BULLETIN NO: M_04_017

TITLE/ PRODUCT NAME: Aristo MA6 – Persistent 19/0 Error Code

Aristo MMC T4, T6, MA4, MA6, & U6

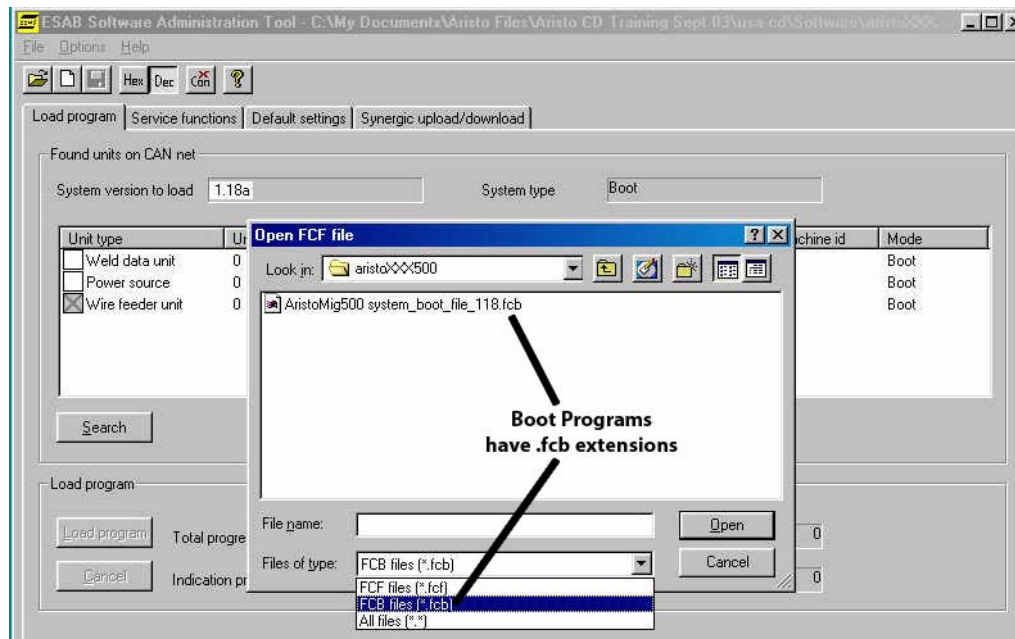
Connect ESAT software and enter the boot mode by powering up the welding system then clicking the “Search” button within 5 seconds. Check the version number of the MMC boot program.

If boot program is not v1.18 and the application software is v1.10 or higher, load v1.18 boot software into the MA6 by loading the .fcb file into ESAT and then loading the program file into the MMC. Once completed, re-boot the Aristo System and complete a “General Reset”. Reinstall any special MMC configuration functions or customer synergic lines.
